VILLAGE OF ARLINGTON HEIGHTS
STAFF DEVELOPMENT
COMMITTEE REPORT

File Number: PC #17-008
Project Title: Sigwalt Apartments/CA Ventures
Address: 37-45 S. Chestnut St., 36-40 S. Highland St.
PIN: 03-30-425-021 thru 023, 03-30-425-012 thru 014

To: Plan Commission
Prepared By: Sam Hubbard,
 Development Planner
Meeting Date: September 27, 2017
Date Prepared: September 22, 2017

Map I – Subject Property and Adjacent Comprehensive Plan Land Designations

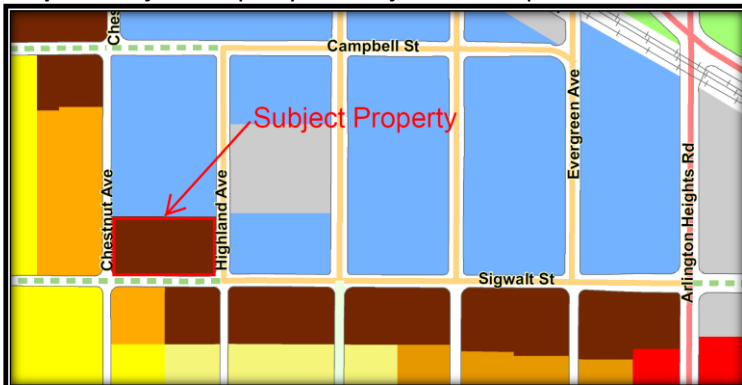
One of the variations relates to the size of the R-7 Zoning District, which in this instance will be 1.39 acres where code requires a minimum of 2 acres in area for land within the R-7 District. Therefore, the following Variation is needed:

- **Chapter 28, Section 5.1-7.3, Minimum Area for Zoning District, to allow the R-7 District to be approximately 1.39 acres where code requires a minimum of 2 acres for the R-7 District.**

The minimum R-7 district size is primarily intended to limit instances of spot zoning on smaller properties that may be contiguous with the B-5 District. Staff notes that the Comprehensive Plan shows the site as one part of a larger strip of R-7 zoned land that is contiguous to the subject property, and when considered in sum, this strip of potential R-7 zoning is over two acres in size. **Map I** (below) illustrates this area, with the subject property outlined in red, the brown areas indicating properties appropriate for the R-7 District, and the blue properties:

When the vision of the Comprehensive Plan is realized, the subject property will no longer be an isolated pocket of R-7 zoning and the variation will no longer be applicable. Therefore, the Staff Development Committee is supportive of the requested variation.
